FLAGLER COUNTY

TECHNICAL REVIEW COMMITTEE COMMENTS

RESUBMITTAL FOR SITE DEVELOPMENT PLAN IN A PUD (PLANNED UNIT DEVELOPMENT) DISTRICT – COQUINA COMMONS

Project #: 2023020081

OVERALL DEVELOPMENT PLAN

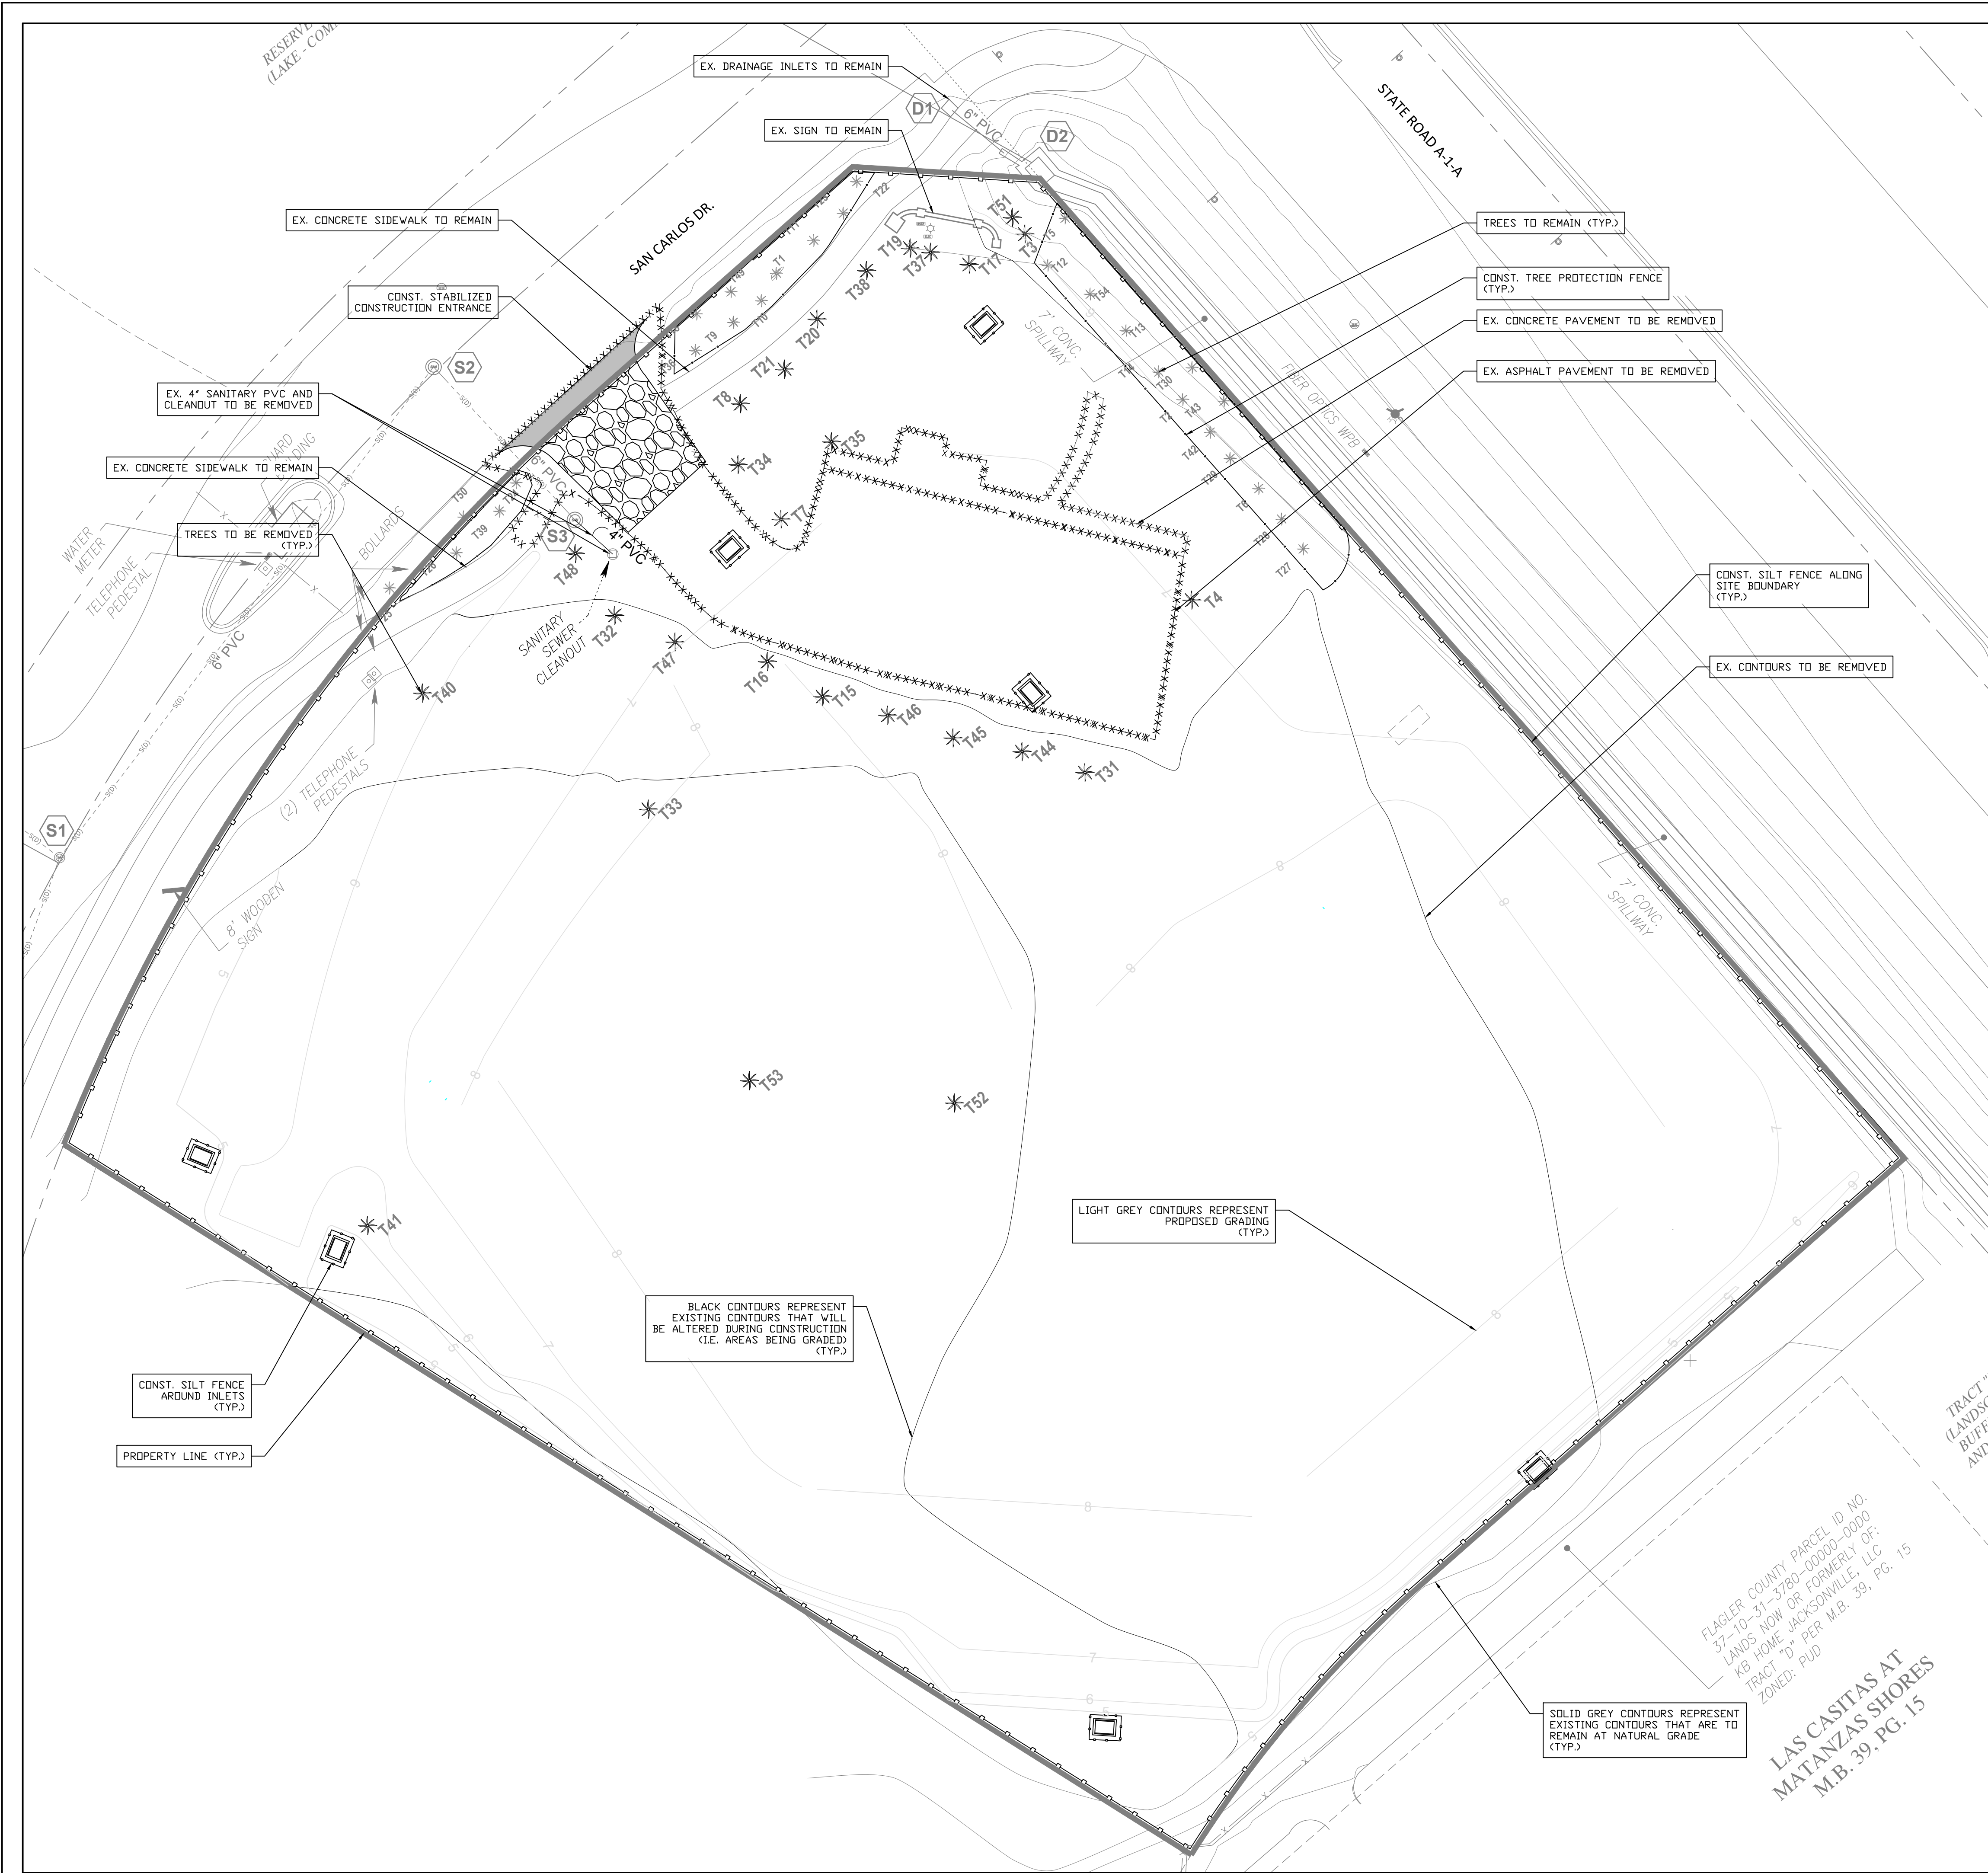
1. All area within the building should be included in the parking calculations.
2. Provide notes on the site plan that the viewing deck will not be used as a part of the restaurant/bar.
3. Sheet 3 of the plans indicates that the viewing deck is above the restaurant.
The area I was curious about is the Northeast corner of the building, I believe it is included as the leasing office? Please label on the site plan.
4. Provide the SJRWMD Permit when received.
5. Has the City of Palm Coast approved the site for water service and the MSOA approved sanitary sewer service?
6. Provide sidewalk access to the existing sidewalk at the property to the South.

DEMOLITION AND EROSION & SEDIMENT CONTROL PLAN

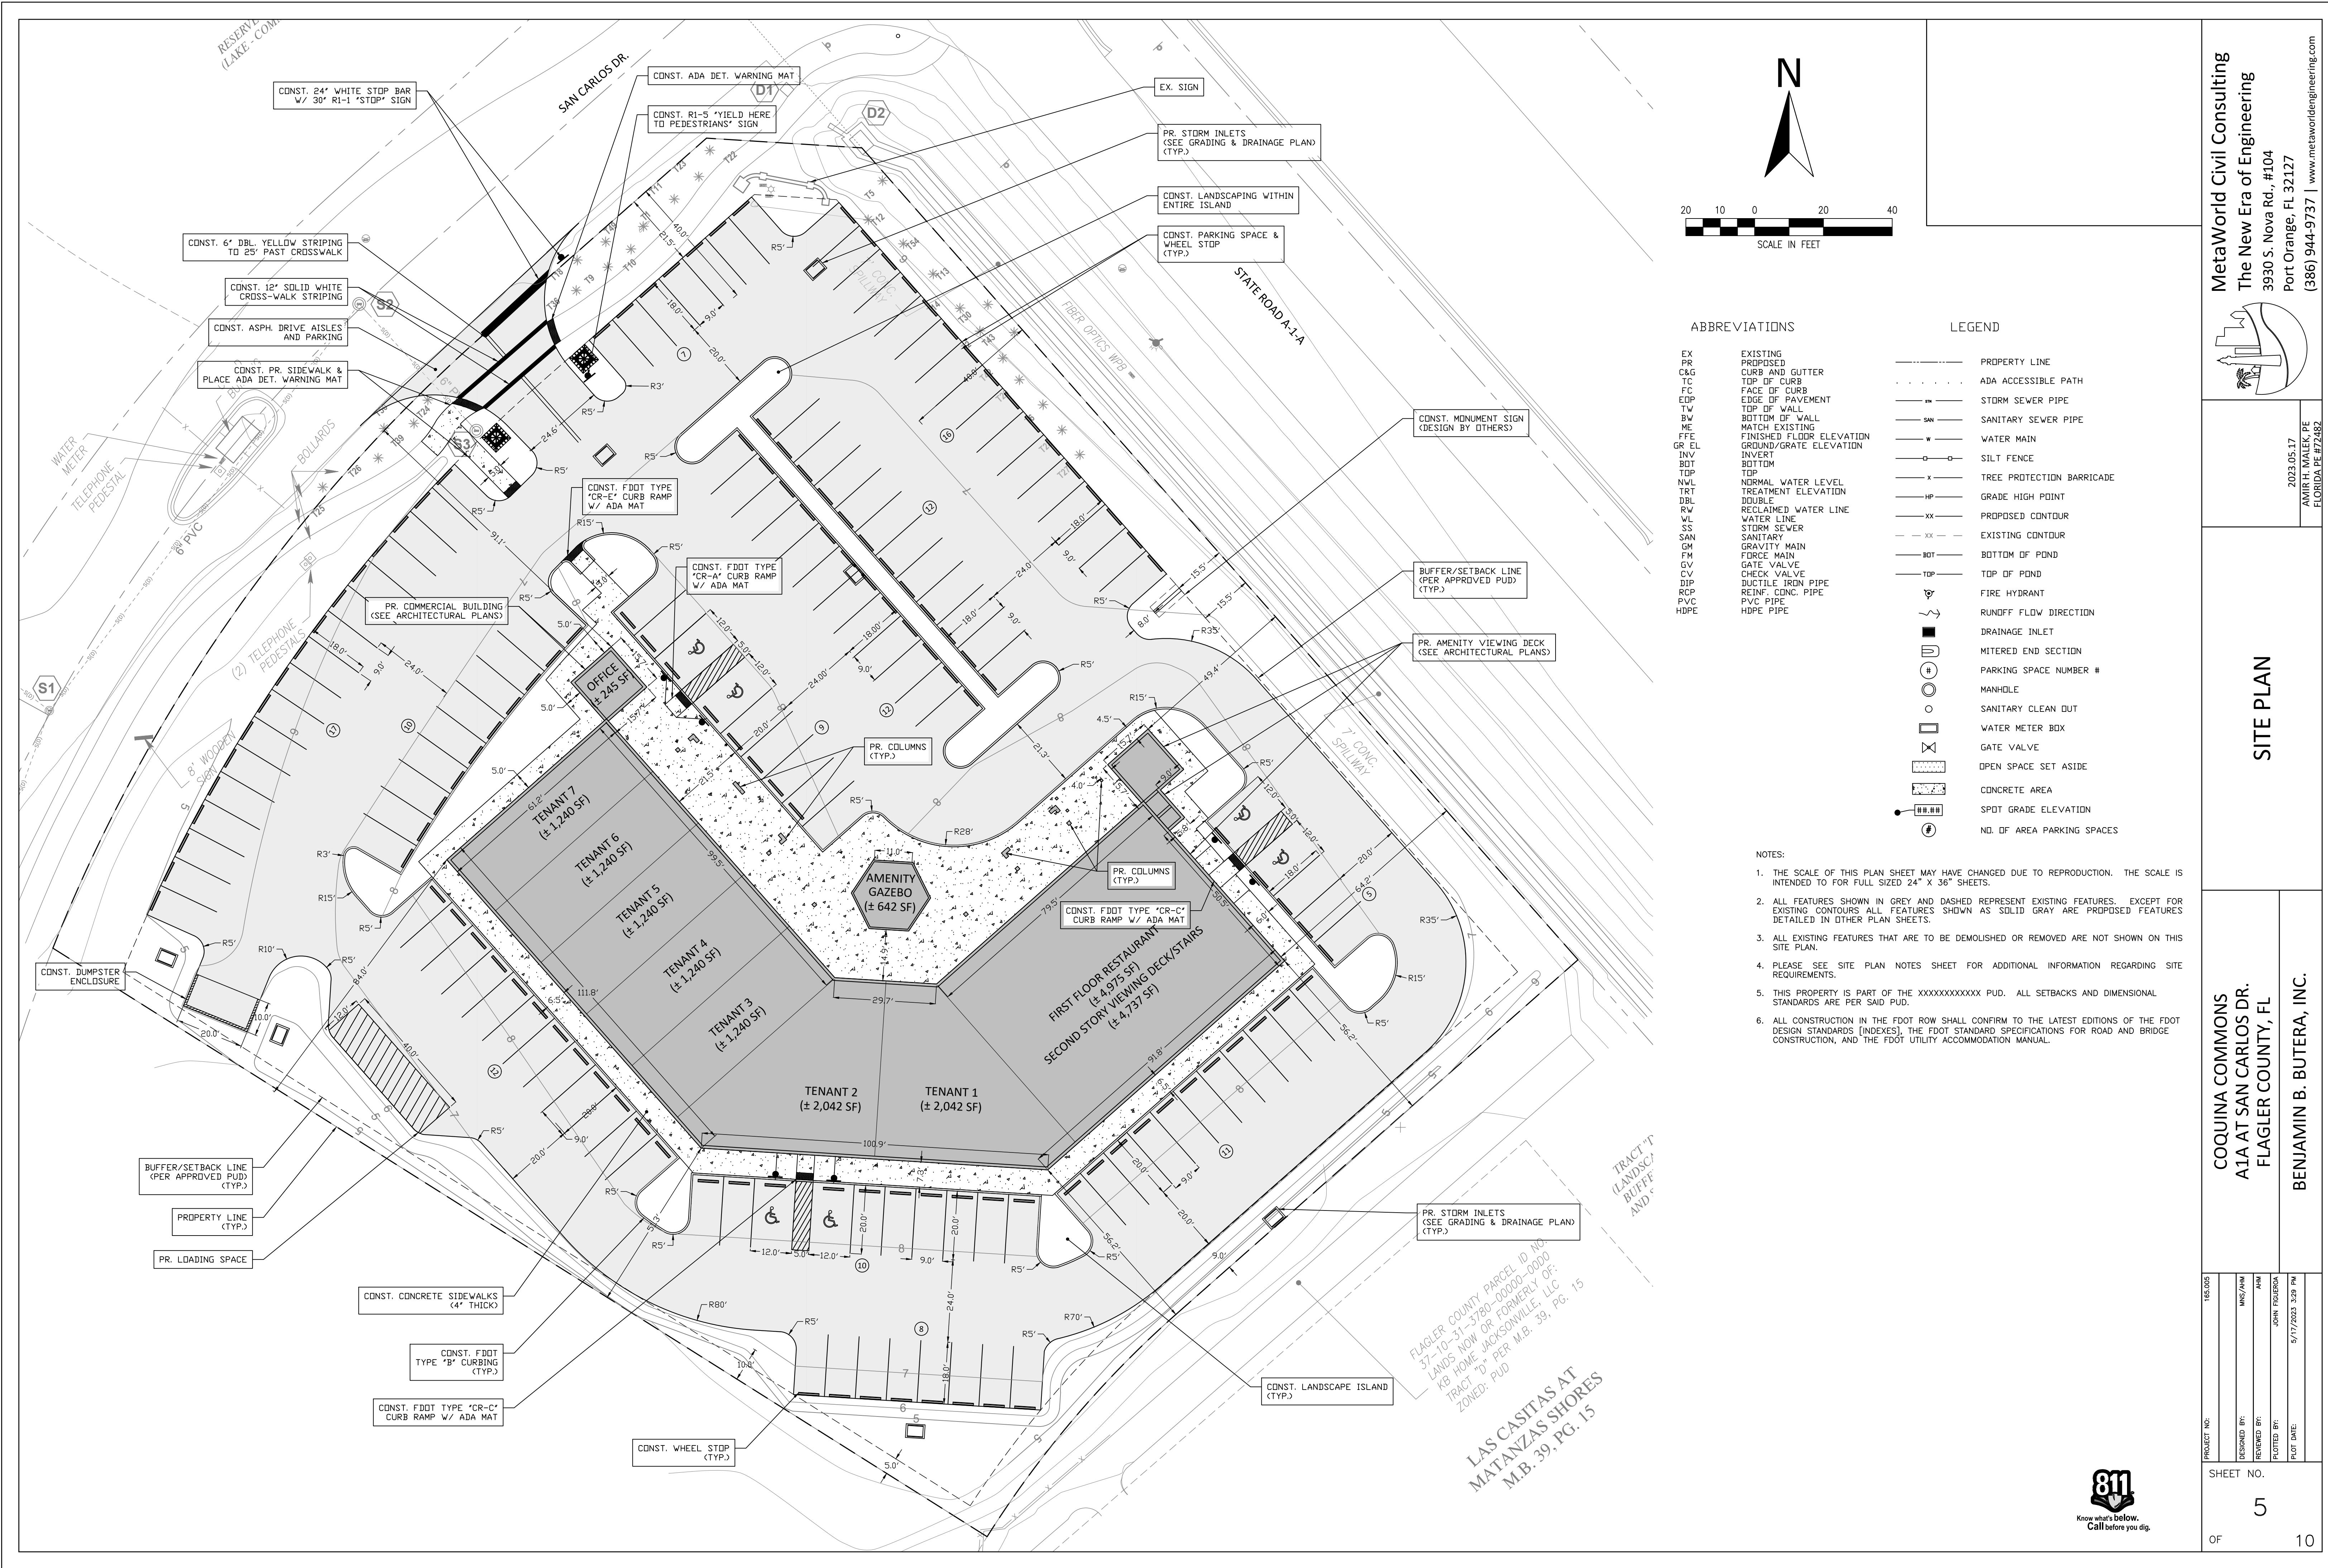
3. There are no index trees (only Sabal Palms) on site according to Sheet 4 of 10 and Sheet LA1 of 4. Please confirm that Existing Sabal Palms outside of the development area will be preserved.

SITE PLAN

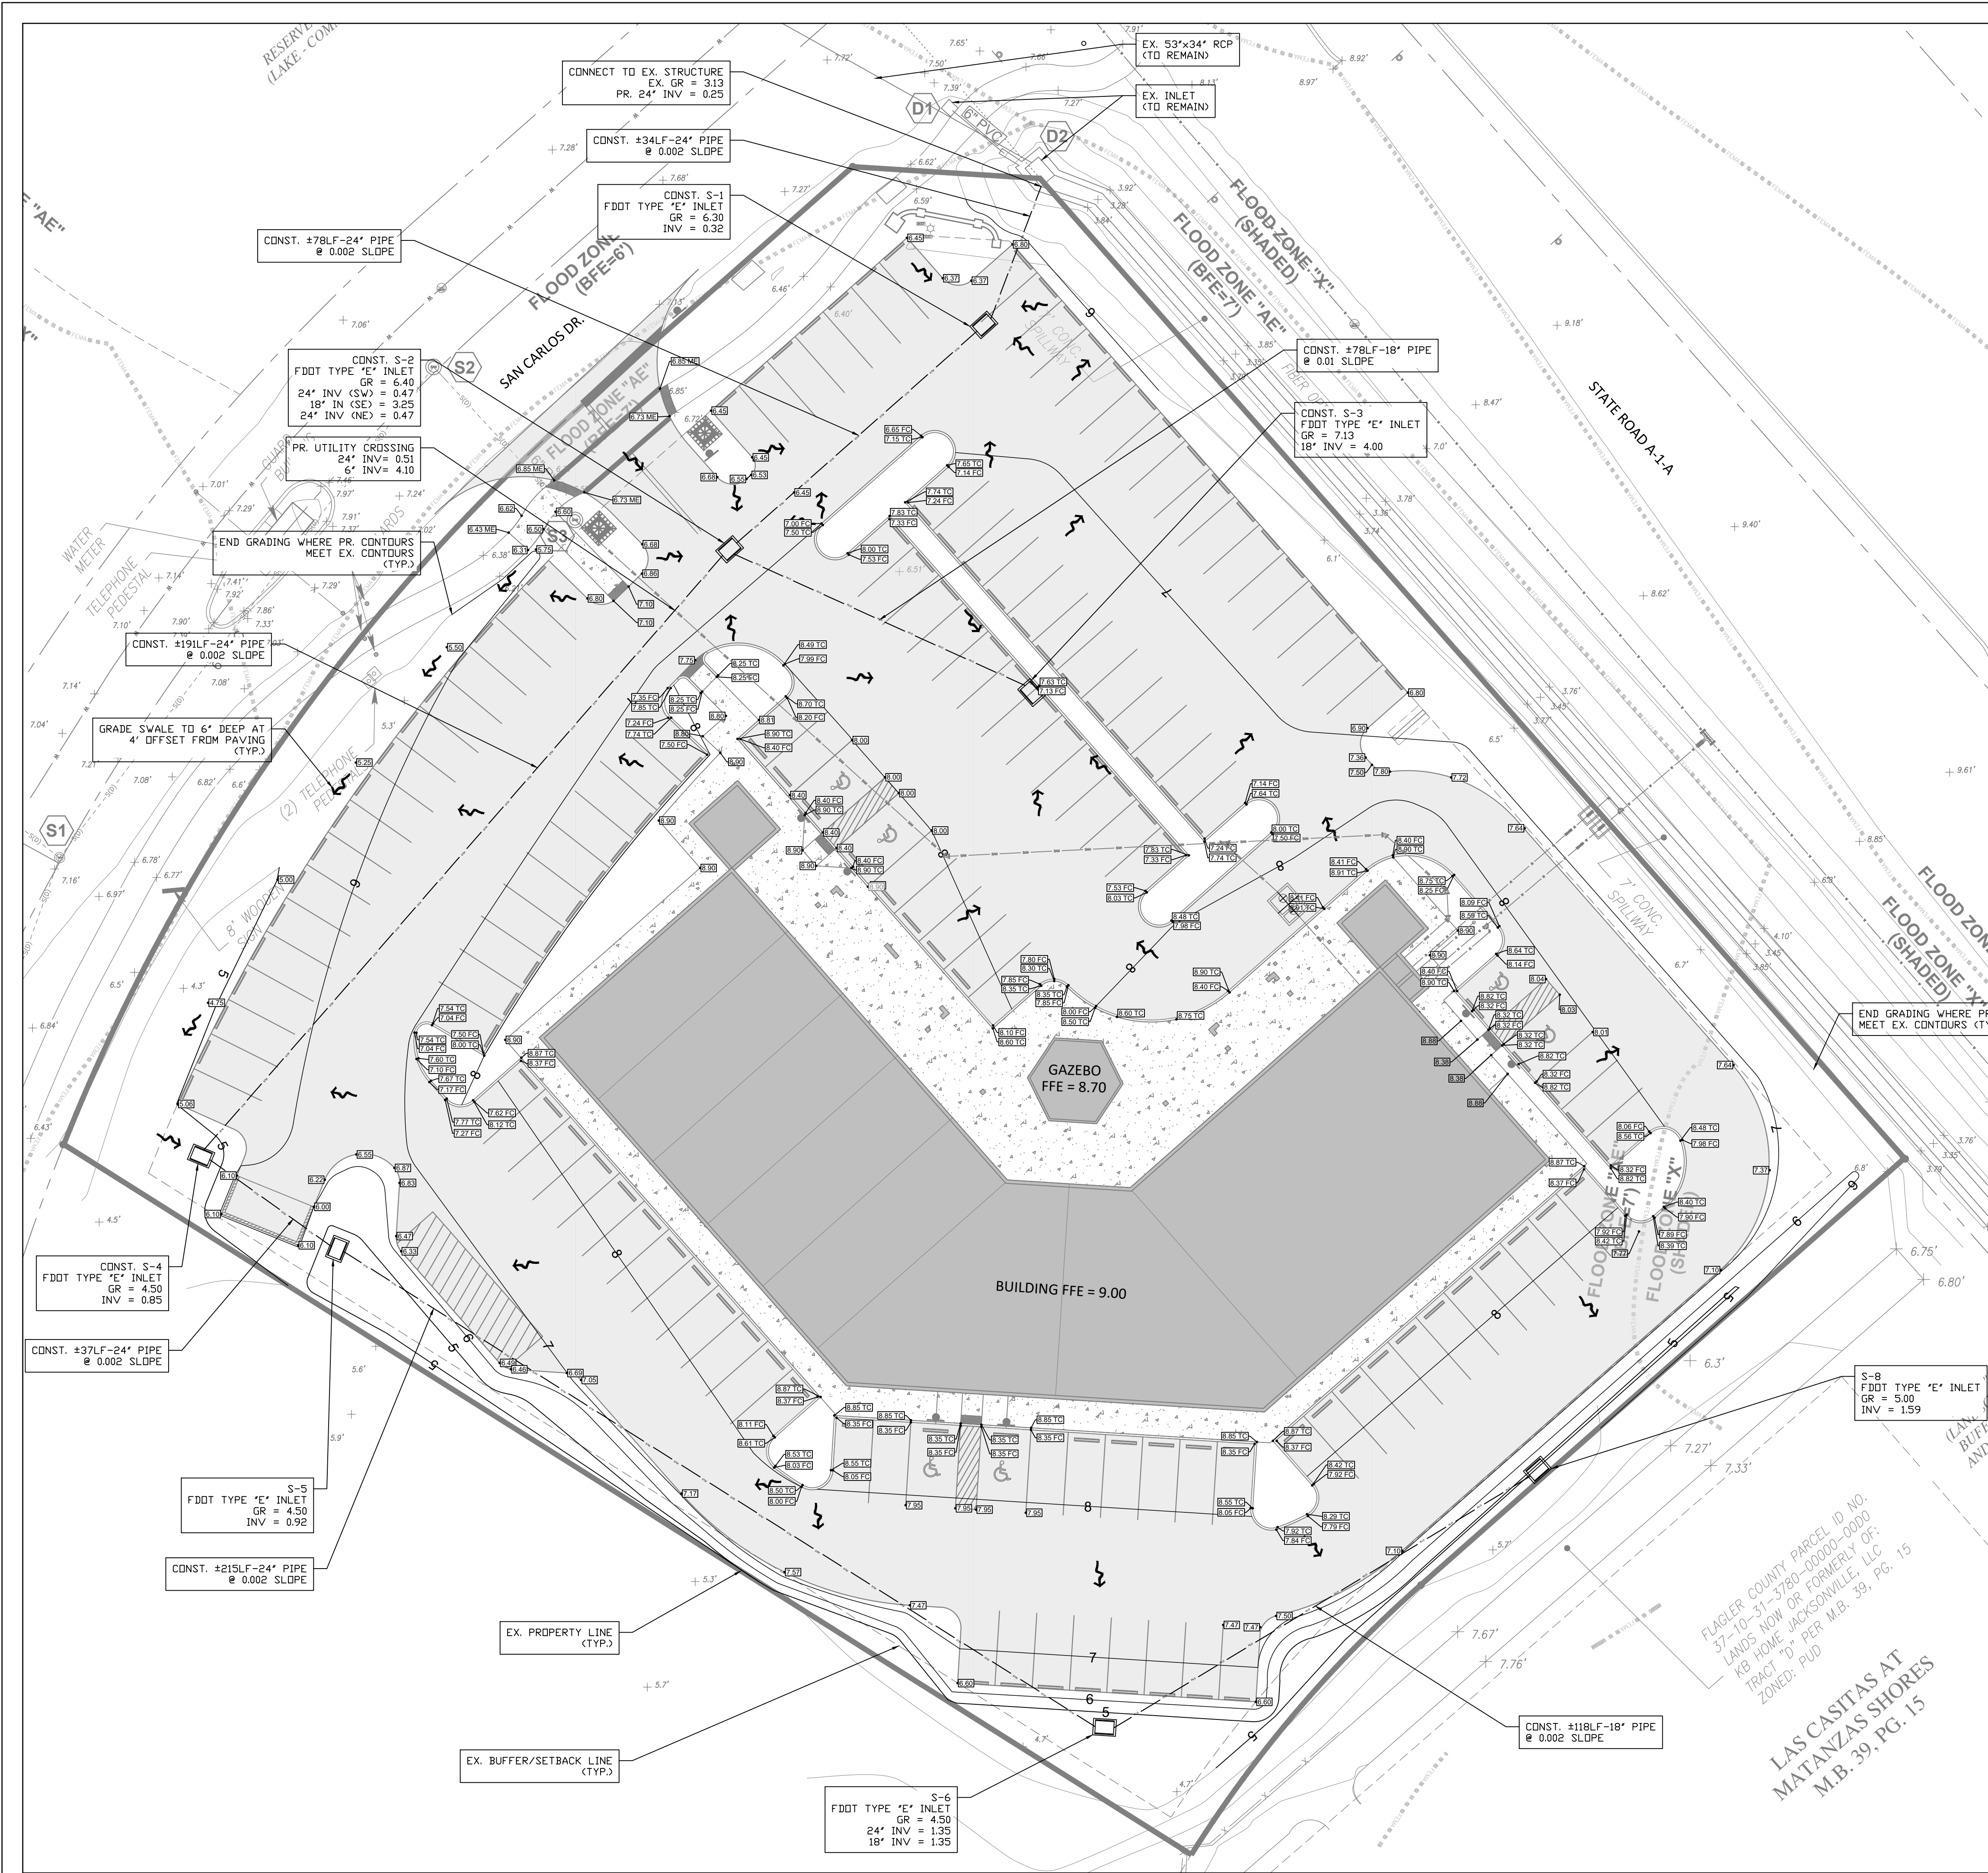
2. Provide setbacks (and label in feet to the nearest parcel line) for both the structure and the monument sign.

4. On Sheet 5, the perimeter parking spaces are all dimensioned as 18 feet by nine feet. LDC Sec. 3.06.04.b.1 requires spaces to be 20 feet by nine feet, with an up to two foot extension of the space depth from the face of the wheel stop into the landscaped area. Please revise.

Please see on Sheet 5 that all proposed structures have been dimensioned to nearest parcel line or that this lies on a dimensioned buffer/setback line.
